**BLANDAIR REGIONAL PARK - PHASE 1 BUILDING CONTRACT**

Project: Blandair Park - Phase 1

Client	Project Name	Drawing No.
	HOWARD COUNTY	BLANDAIR REGIONAL PARK - PHASE 1	RFI 016A-1
WHITMAN, REQUARDT & ASSOCIATES, LLP 8250 BENDIX ROAD COLUMBIA, MD 21045	9250 BENDIX ROAD COLUMBIA, MD 21045	Drawing Title	Check: AUO
Scale: 1" = 10'	Date: 6/20/12	RFI 016A	Drawn: CYH
			Des: CYH

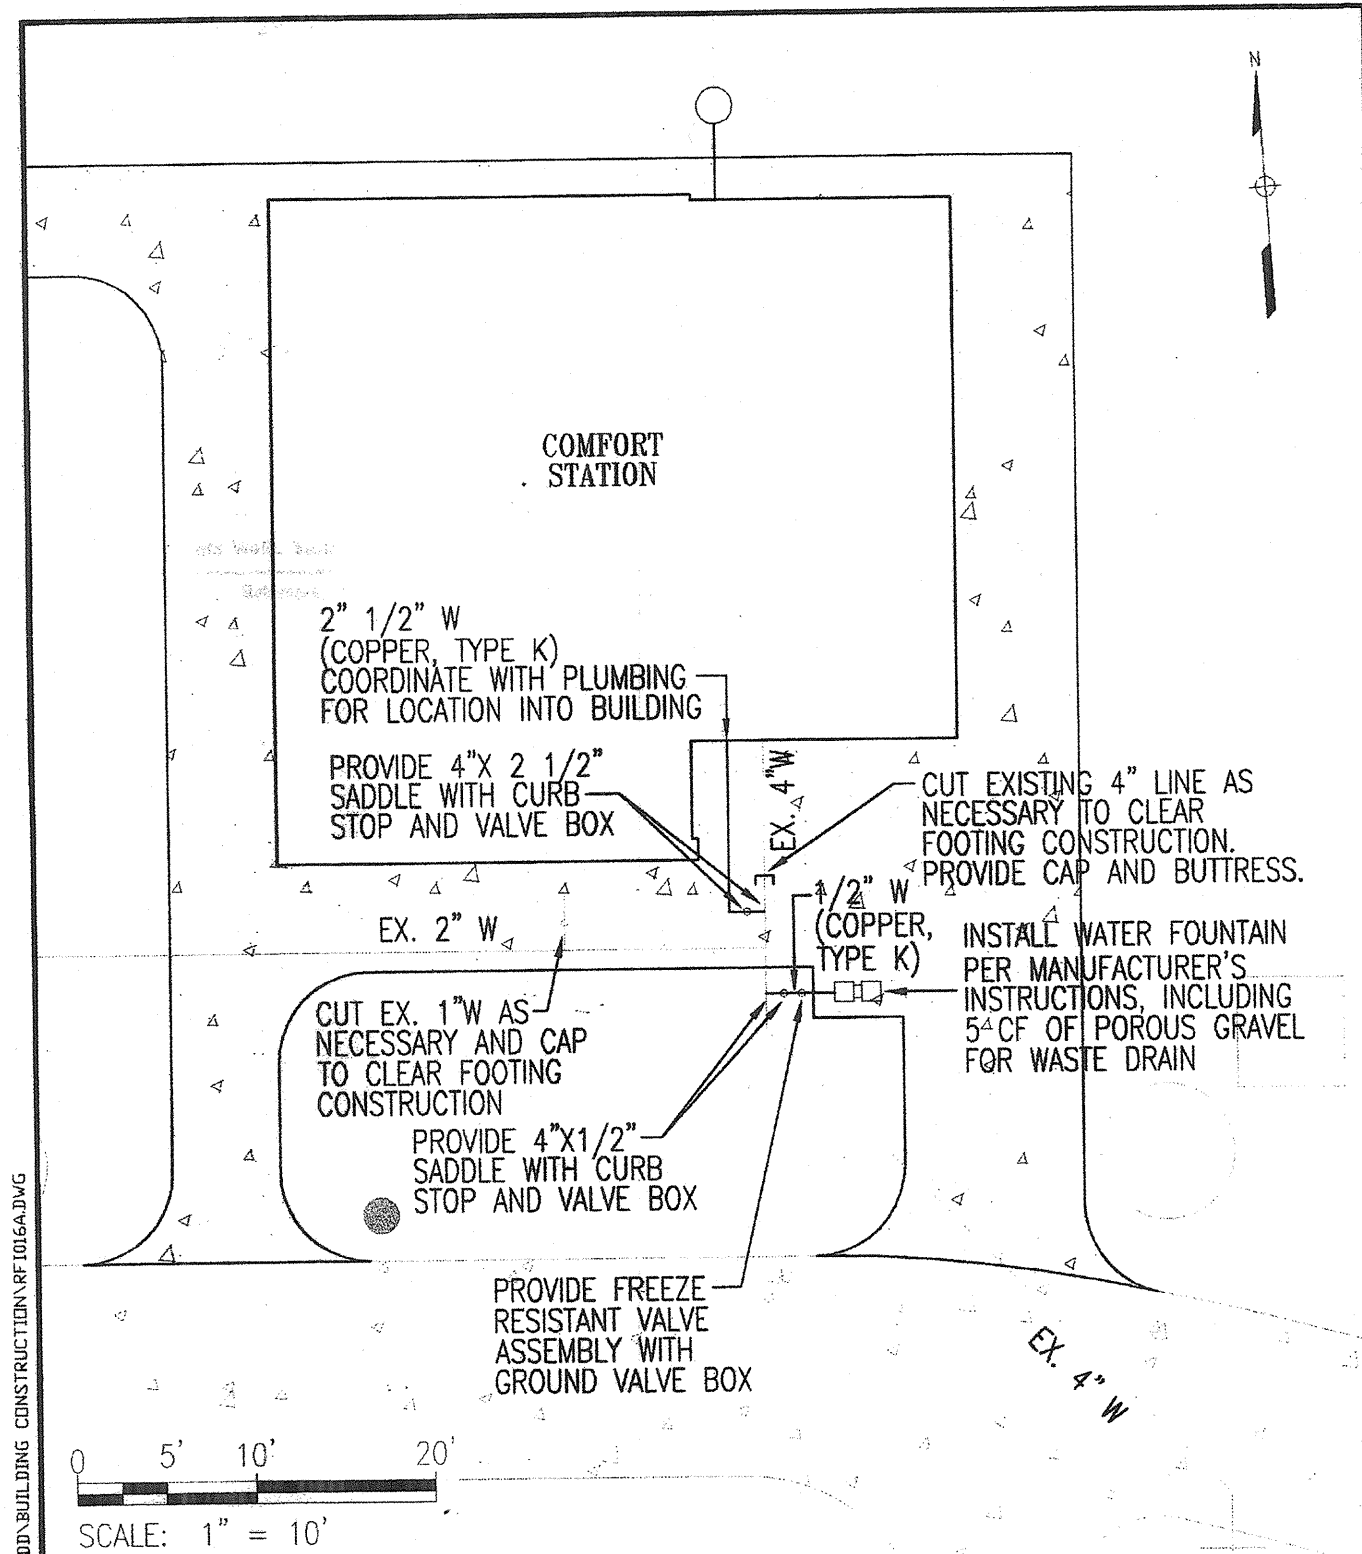
Sheet C3.1 detail D shows the existing incoming water service to be a 2-1/2" line. Please confirm that we are to continue the 2-1/2" line into the building. Also, you will notice on the attached sketch there is an existing 1" water line that is not shown on Sheet C3.1. This 1" water line interferes with the footing layout and we request that this line be removed back to a point outside of the footing footprint and capped. There will be cost associated with the removal of the 1" line. The plumber has agreed to do this work on a T&M basis and the work should not be more than (2) days for his crew. Please confirm this is acceptable.

Client	Project Name	Drawing No.
	HOWARD COUNTY	BLANDAIR REGIONAL PARK - PHASE 1	CL-01
WHITMAN, REQUARDT & ASSOCIATES, LLP 8250 BENDIX ROAD COLUMBIA, MD 21045	9250 BENDIX ROAD COLUMBIA, MD 21045	Drawing Title	Scale: 1" = 30'
Des: CYH	Drawn: SAD	CLARIFICATION 01	Date: 07/12/12
			Sheet 1 of 1

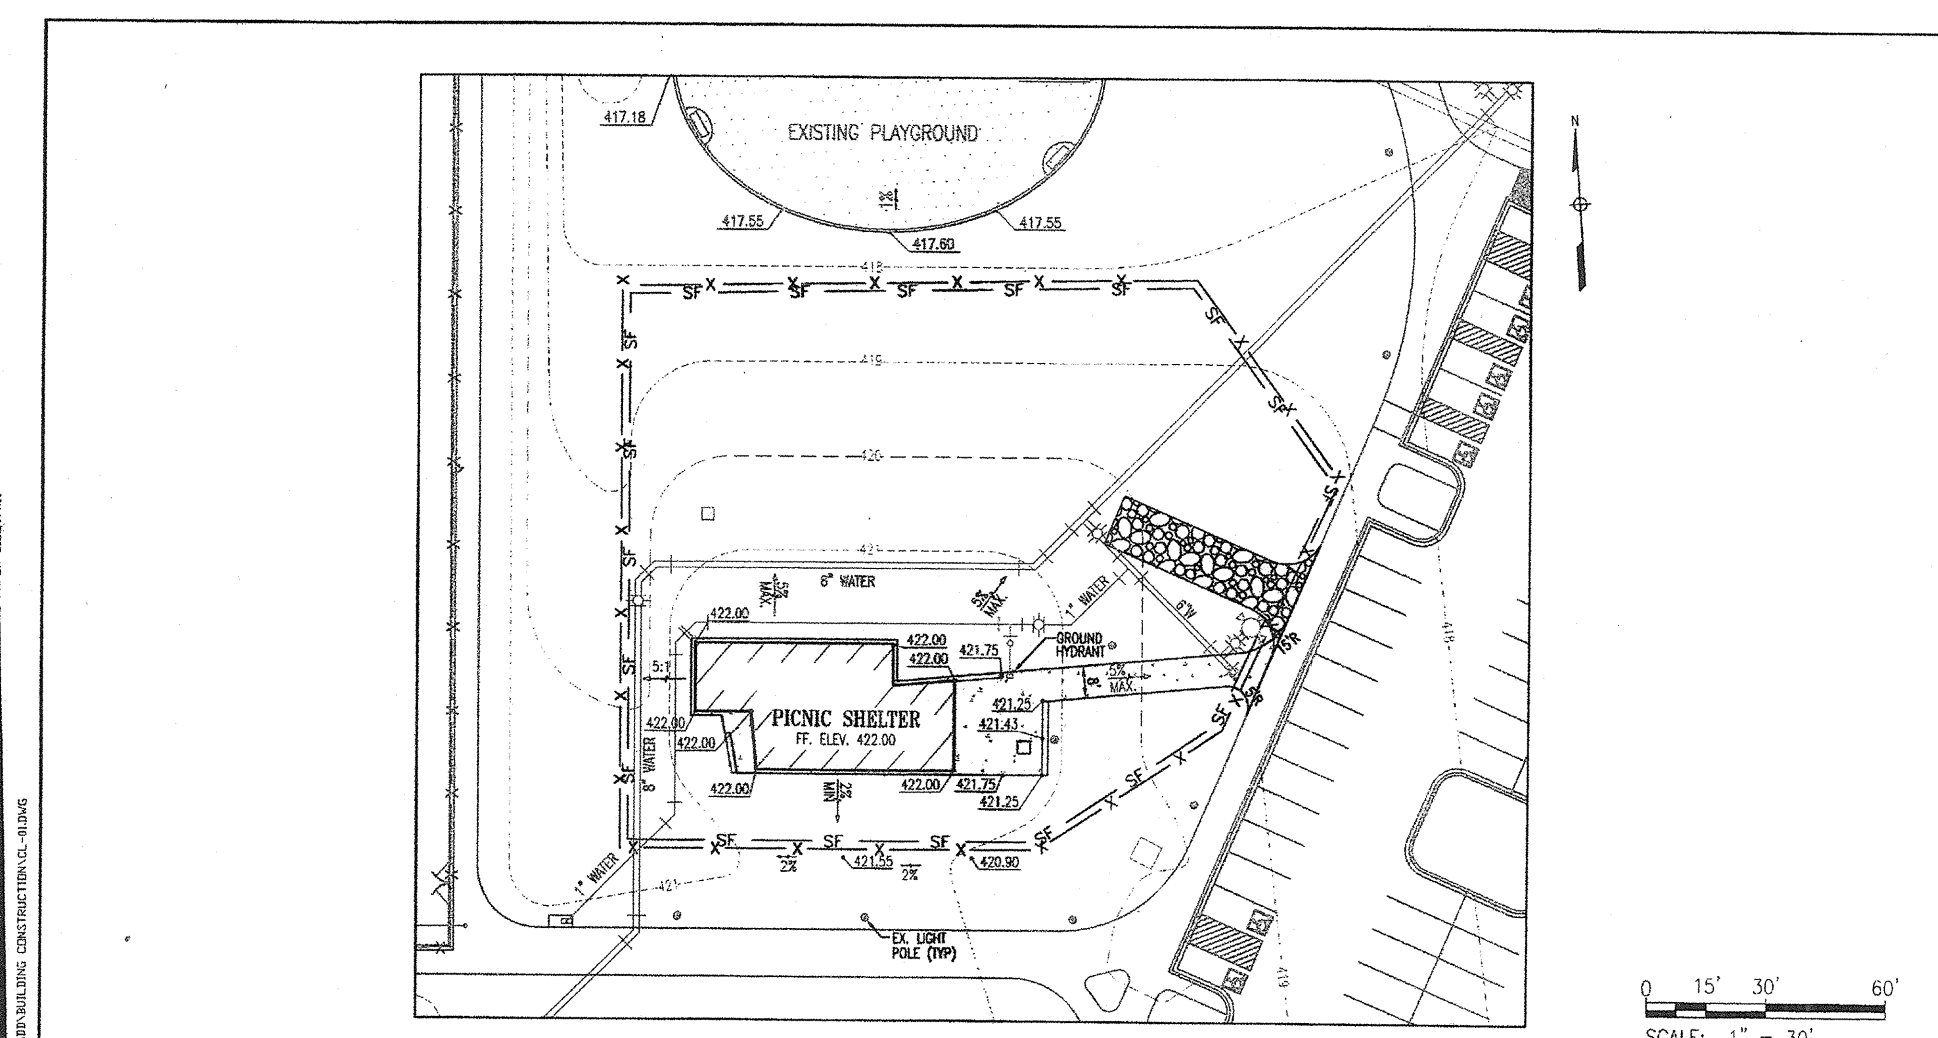
The Picnic Shelter area existing grade elevations are approximately 1.0' lower than what is shown on civil drawing C1.2. Would the Owner like us to fill the site to proper elevation using the contingency unit prices and allowance to bring the site to proper grade after the foundation work is completed? The alternate would be to lower the footing depth by extending the cast-in-place pedestal height to install the footings below the frost line. Extending the footings could potentially delay the project further as reinforcement will change due to design changes. Both changes have cost implications however the first option will not affect the schedule. Please advise.

The preferred solution is to raise the existing grade and not lower the footing elevations. Per Specification Section 010000 - General Specifications, paragraph 1.6A and note 6 on Sheet C1.1, the Contractor is solely responsible for the authenticity of the existing field conditions. The Contract documents did not guarantee the elevations of the existing grade. These conditions should have been considered with the Contractor's lump sum bid and should not be an additional cost to the Owner.

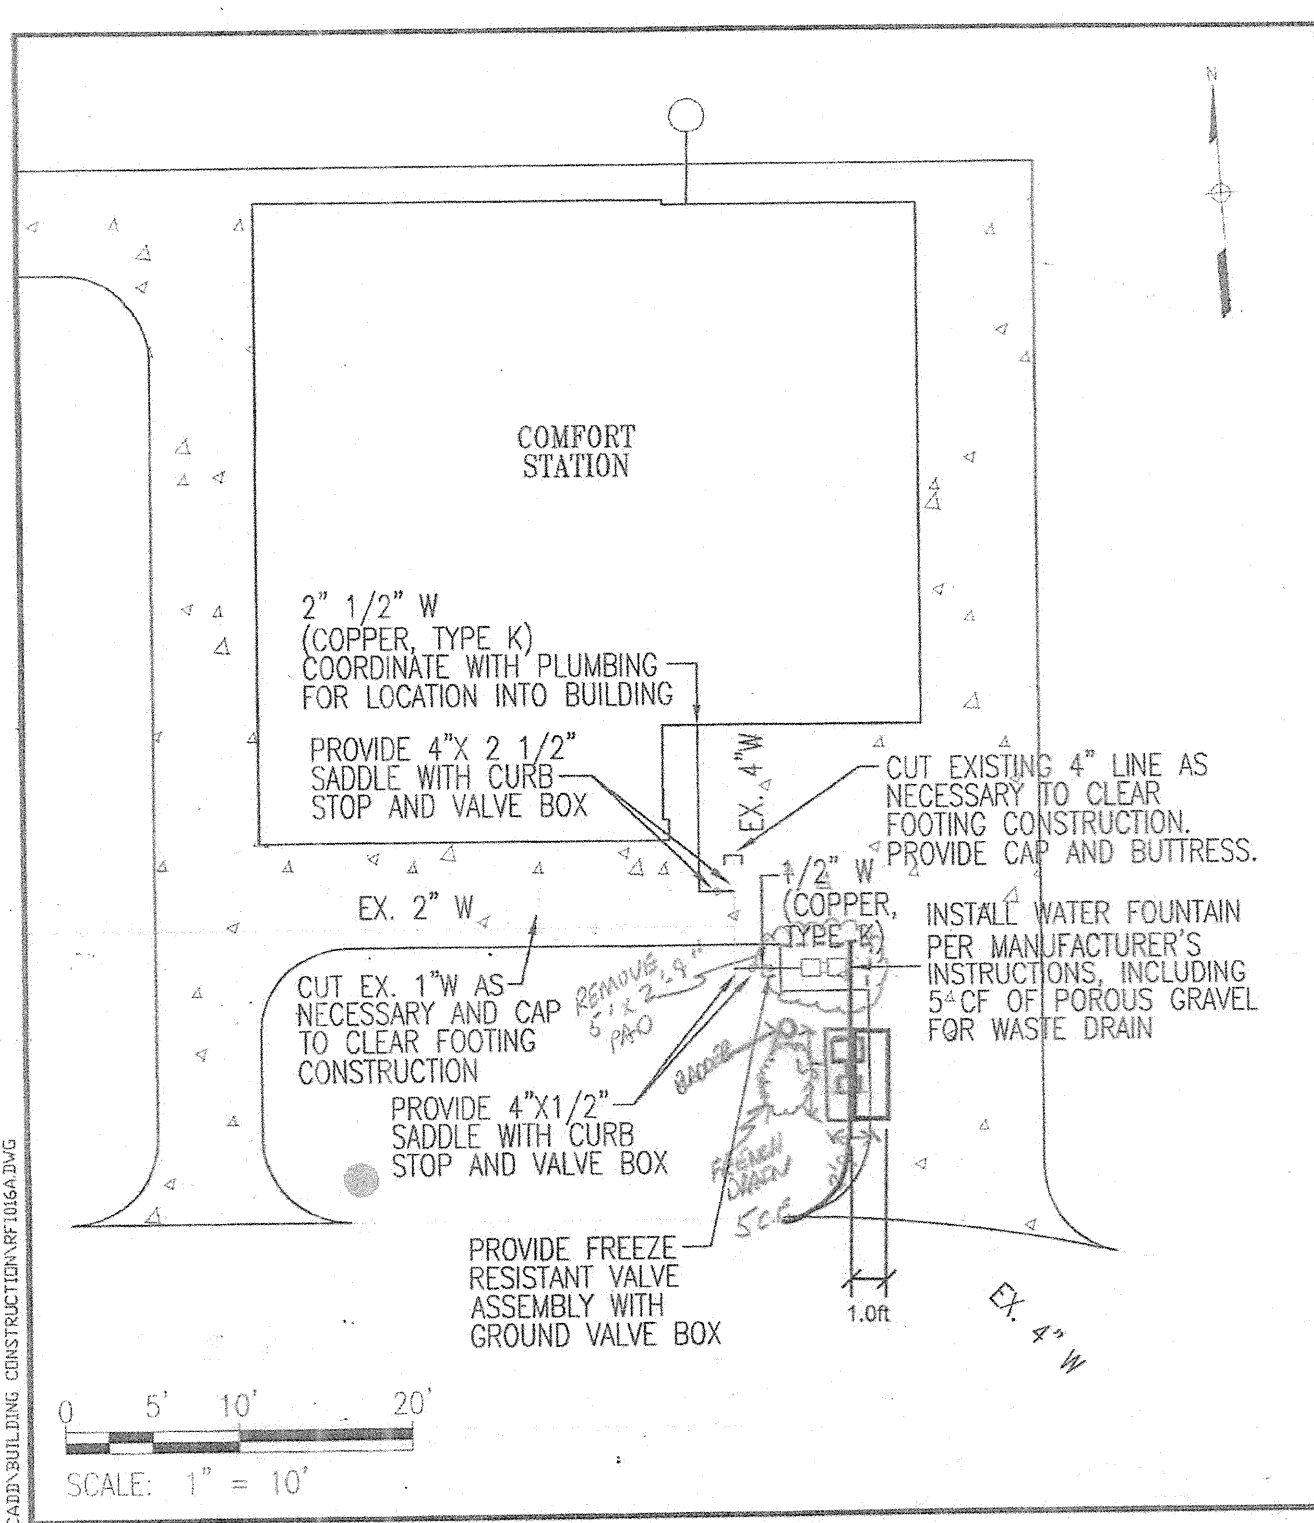
Question: On sheet L2.1 it shows the location of the Drinking Fountain. There are too many conflicts that occur in this general area due to: existing underground utilities, LP ground ring, length of lines connecting from bladder to drinking fountain, and installation of the 5 C.F. underground french drain.

Suggestion: Remove the 5'-0"x2'-9" CONC pad and location of drinking fountain and install bladder with underground french drain shown in the attached document. The proposed relocation of the drinking fountain will also allow the ground valve box to be placed in the ground in lieu of the concrete sidewalk.

Answer: See attached response by WRA

1 COMFORT STATION - FLOOR PLAN  
A1.1 1/4" = 1'-0"

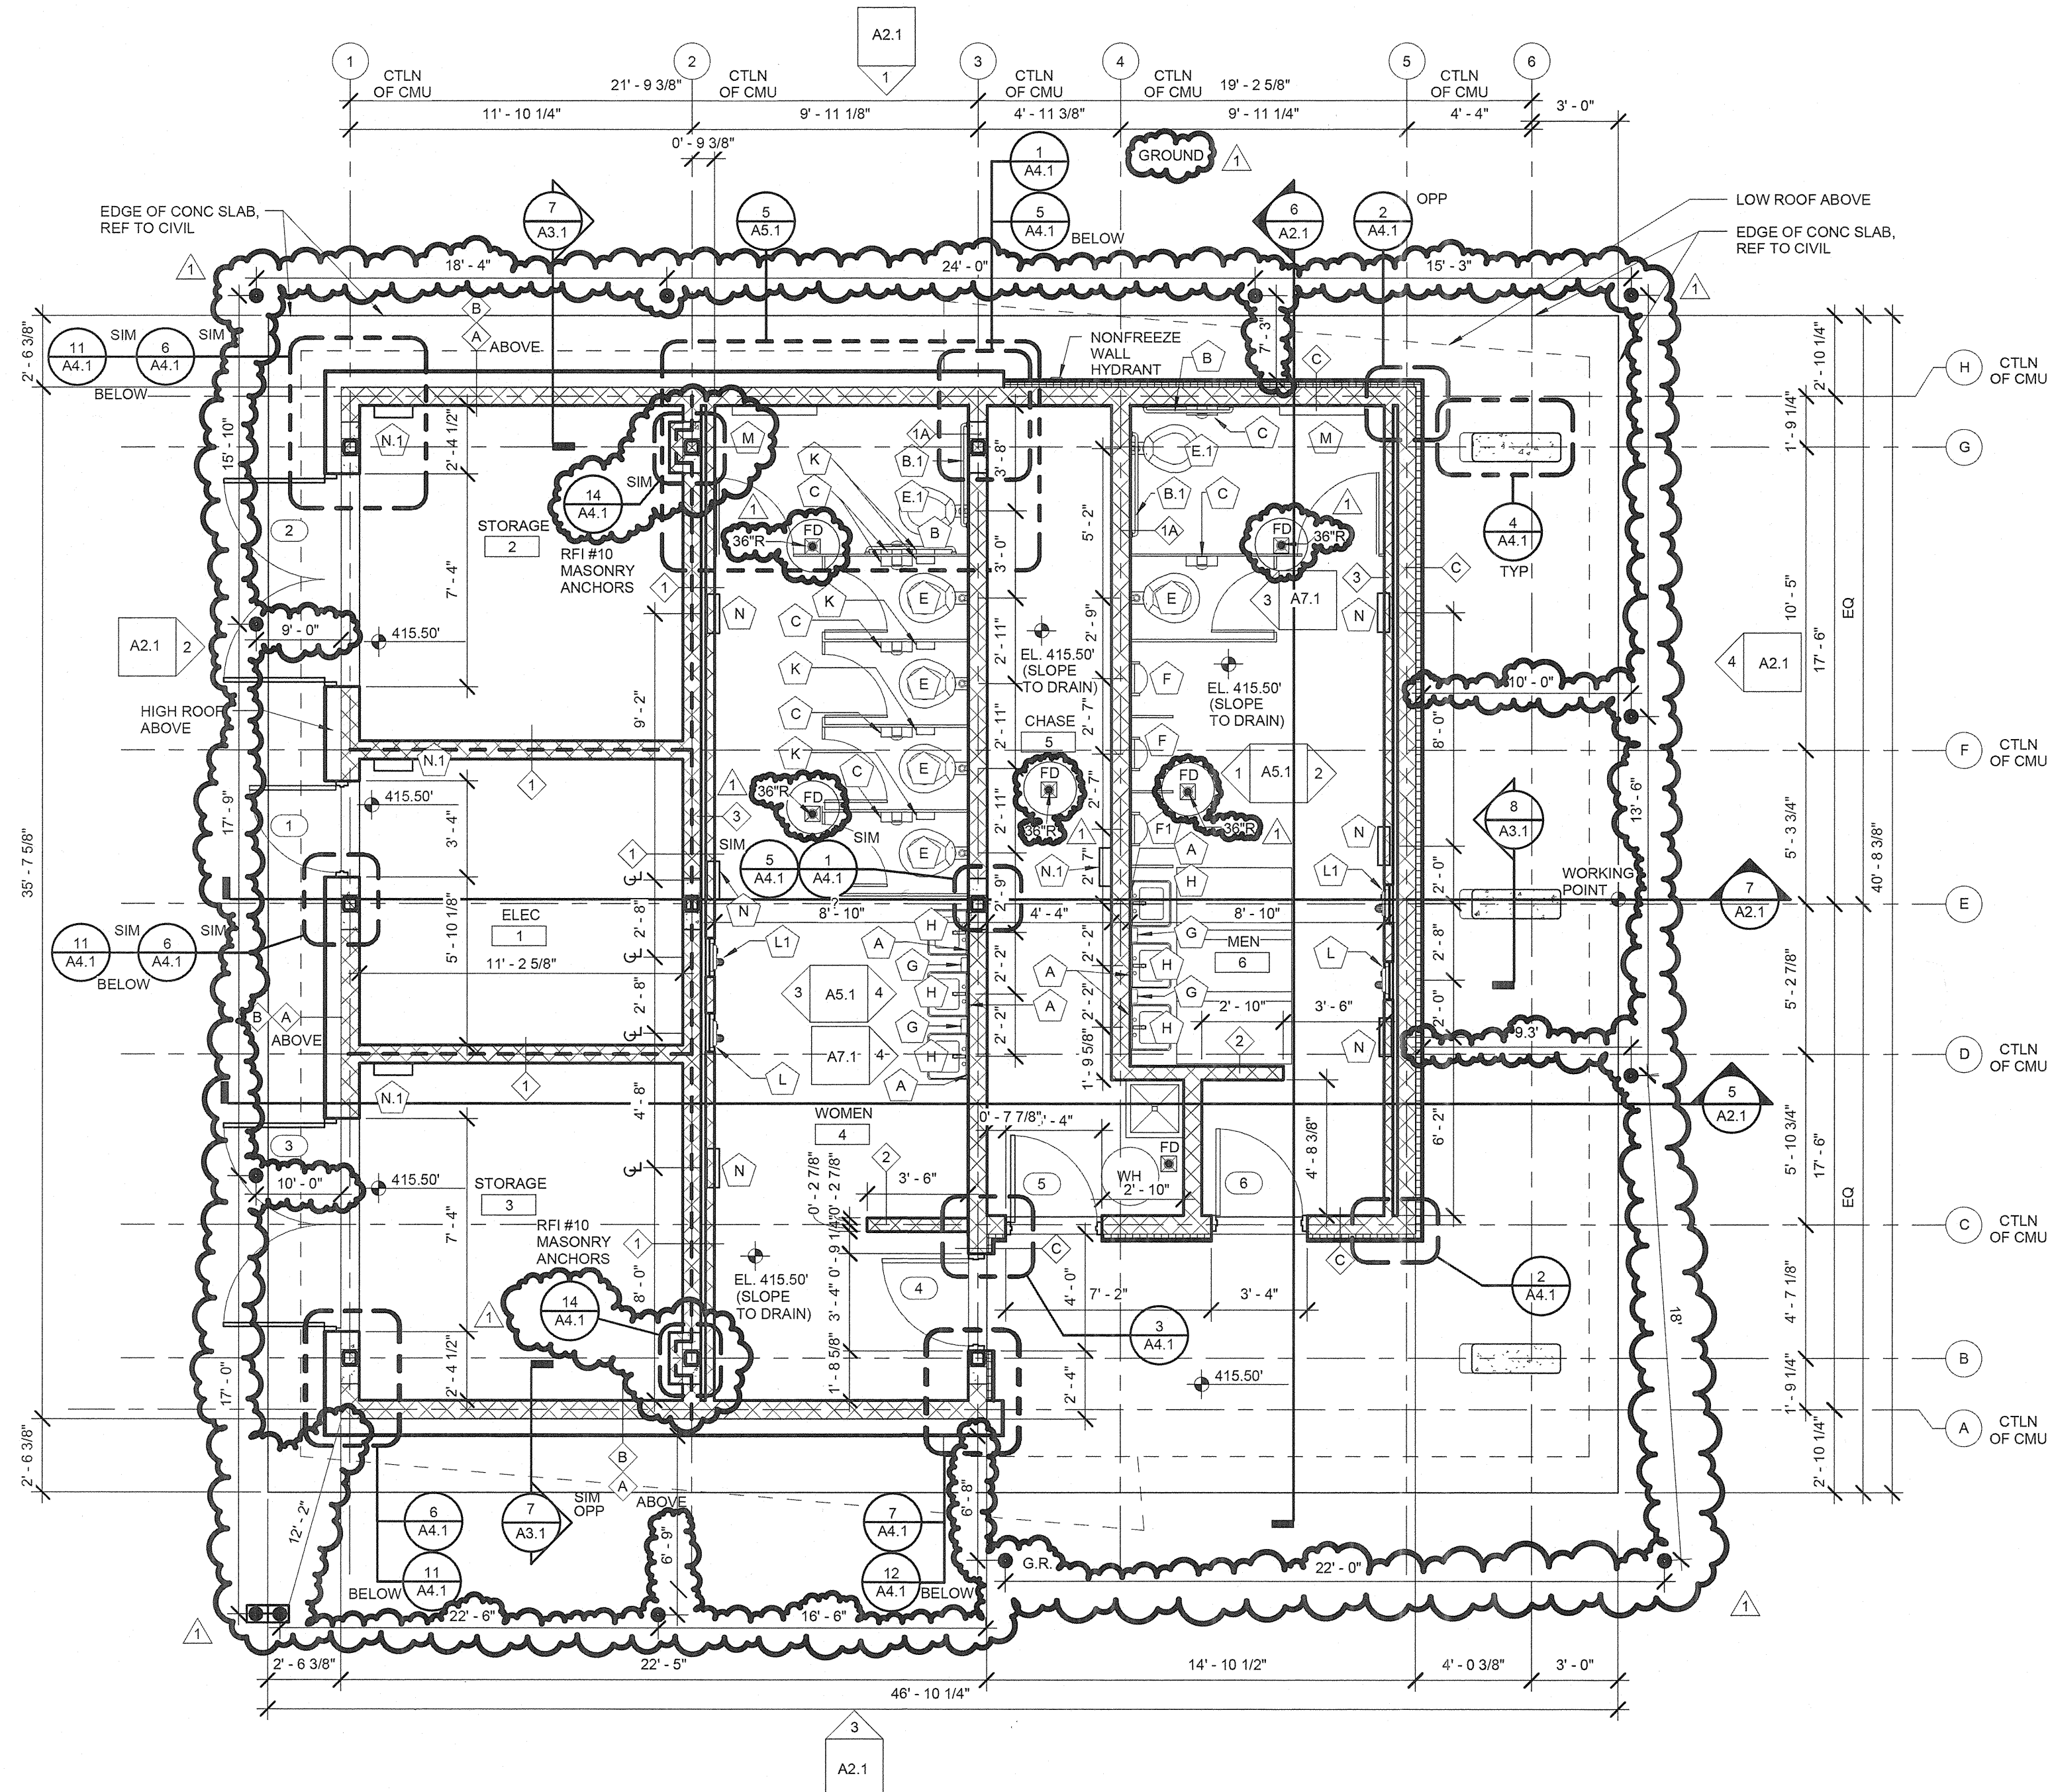
RFI #10 MASONRY ANCHORS  
THE CAST IN MASONRY ANCHORS FOR THE 6" CMU IS ONLY TO BE USED AT COLUMNS B2 & G2 ON THE STORAGE SIDE. DETAIL 14-A4.1 IS REFERENCED IN 1-A1.1 COMFORT STATION - FLOOR PLAN @ COLUMNS B2 & G2.
